R44 SERVICE LETTER SL-40

SUBJECT: MRGB Oil Level Fluctuation

ROTORCRAFT AFFECTED: R44 helicopters S/N 2065 thru 2121, and R44 II helicopters S/N 12848 thru 13127, unless previously accomplished.

FIGURE 1

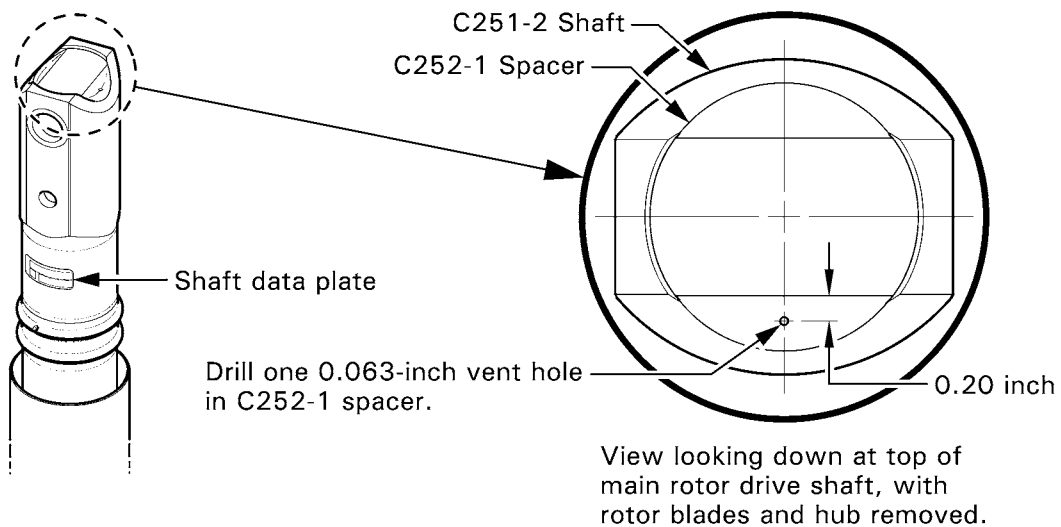
1. Refer to Figure 1. If data plate indicates C251-2 shaft is revision P (or subsequent), or if C251-2 revision O (or prior) shaft's data plate is marked with a yellow paint dot, the recommendations of this letter have been complied with and no further action is necessary.

4. Refer to Figure 1. Mark hole location in C252-1 spacer as shown; remove sealant as required.
5. Vacuum debris while drilling and slowly drill 0.063-inch diameter hole thru spacer (material is 0.060 inch thick aluminum; adjust drill stop accordingly).

6. Mark shaft data plate with yellow paint dot in upper left corner.
7. Install main rotor hub per MM § 9.122.
8. Install main rotor blades per MM § 9.112.
